# **79 AVENUE ROAD**

ADDENDUM B

# **BASEMENT**

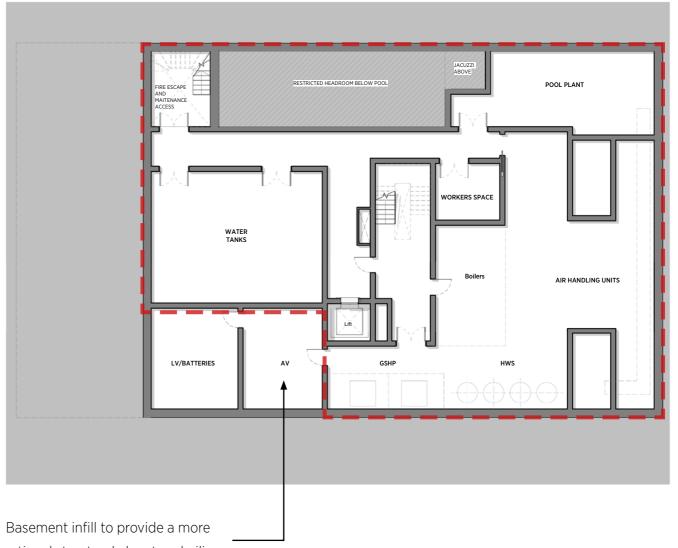
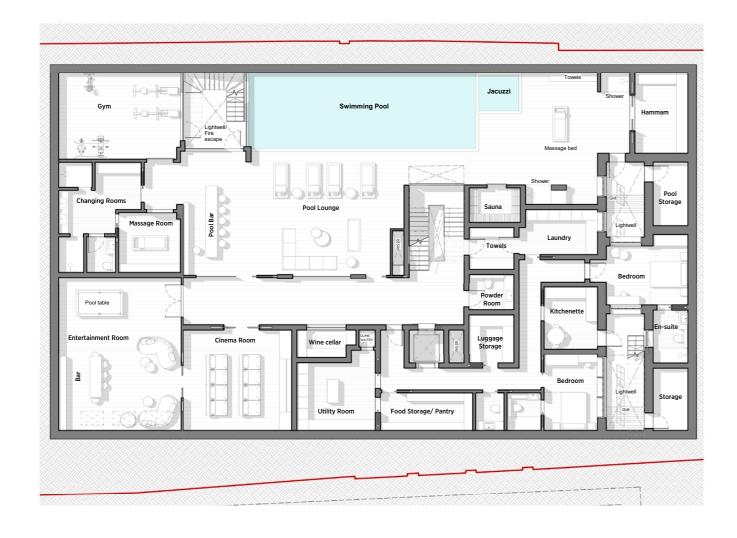
It is proposed to infill the cut-out basement corner to allow for extra plant room area at basement level. The proposed footprint will allow for a continuous piling line and a more rational structural approach.

It is also proposed for the lift to serve the basement level and therefore the lift pit is relocated just under the basement slab.

rational structural alyout and piling

# **GROUND FLOOR**

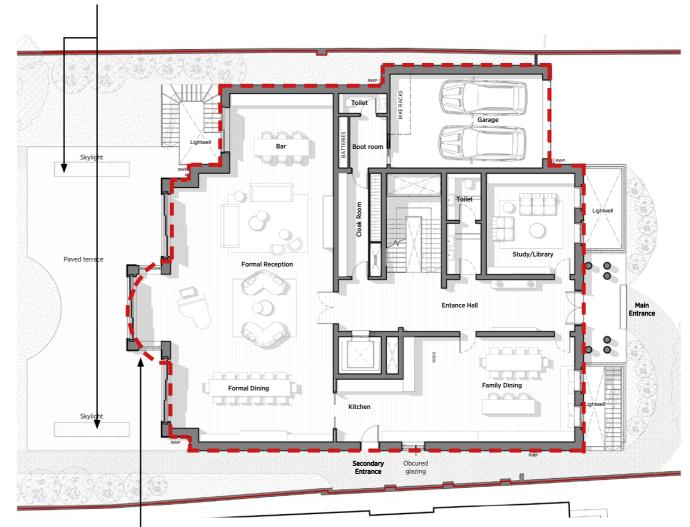
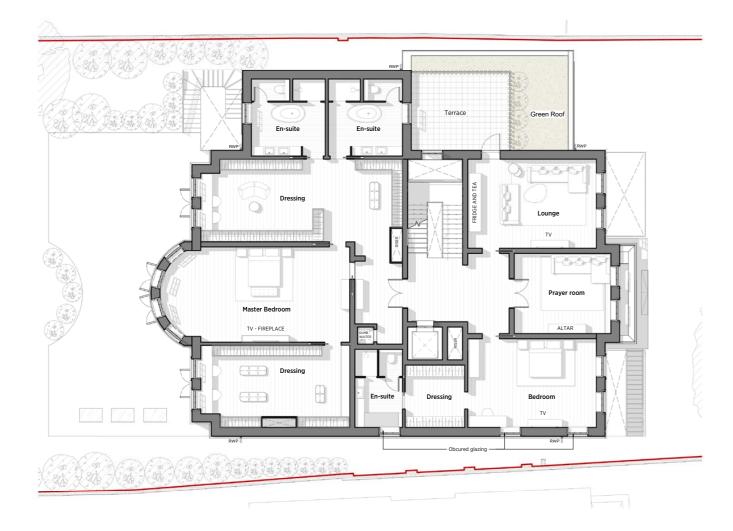
At ground floor in the rear terrace combining the 3 consented smaller skylights into a single large skylight. In addition a rooflight has been proposed simmetrically on the opposite side of the terrace to maximise the natural light into the rooms at basement level.

Single large rooflight and an additional rooflight providing more natural light to the basement

Square bay and contemporary sliding doors to increase connection to the rear garden, and natural light into the internal spaces

# **FIRST FLOOR**

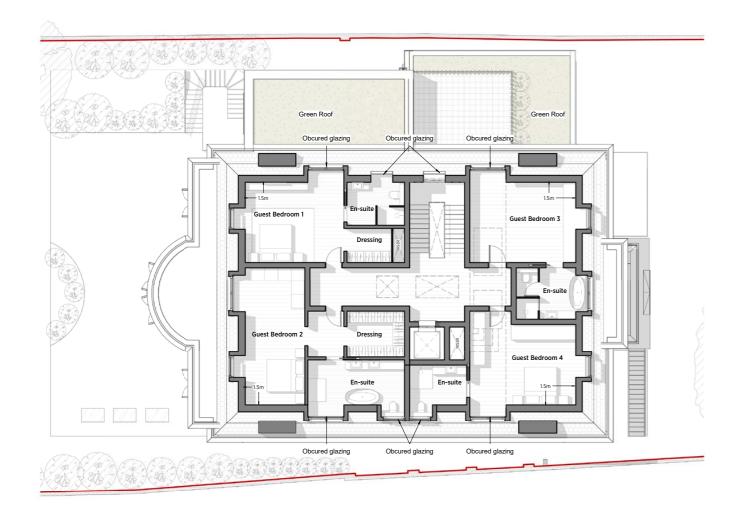
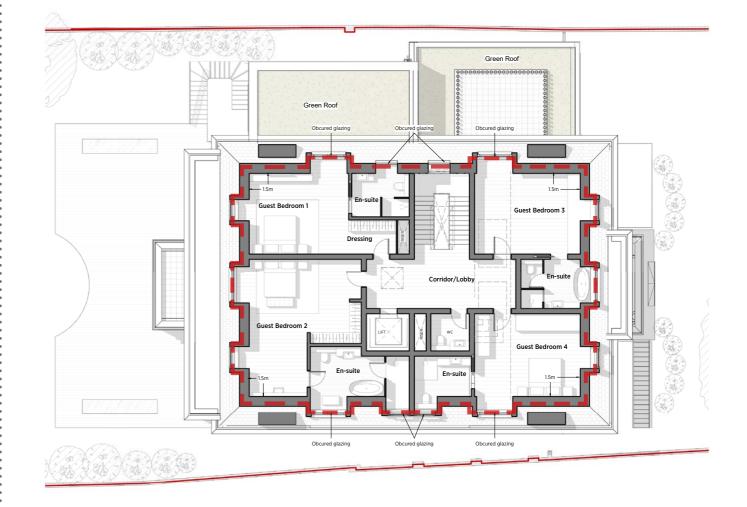
Centralised terrace and French doors add symmetry to the facade and natural light to the internal space whilst providing more privacy to the En-suite

Small terrace off of the master bedroom provide views to the rear garden

# **REAR ELEVATION**

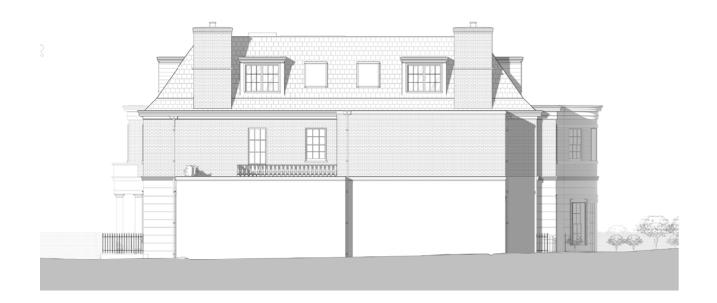
The proposed rear elevation maintains at first floor the classical elements of the original design, with sash windows, French doors, red brick and use of natural stone for the windows surrounds and cornices. A central, small terrace is introduced to the Master Bedroom to provide an external space from where enjoy the views of the rear garden. The terrace is located away from the building's perimeter and prevents overlooking issues into neighbour's gardens.

The proposed ground floor rear elevation retains the magnificence of the natural stone and white render details with a central square bay. It is proposed to have more simple and contemporary doors for a better view and connection to the garden.

The overall appearance of the building looks harmonious and in line with the local settings, with a traditional and classical design of the overall building and a subtle modern touch at ground floor.

The adjustment in the rear façade has been designed so that the area has not been increased, the overall GIA will remain the same.

# **SIDE (NW) ELEVATION**

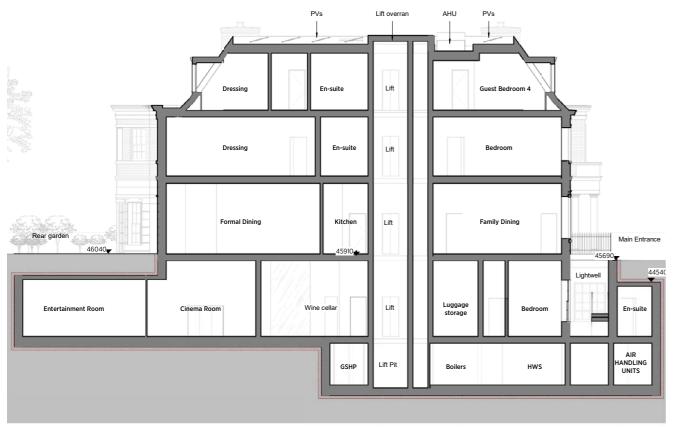
An additional traditional sash window is proposed to the side elevation above the garage to allow for natural light to the lounge area at first floor. It is proposed to have a double door to access the first floor terrace, which is symmetrically located in between the two windows.

All the windows on the side elevations, including the additional window, are proposed to have obscured glazing and restricted opening.
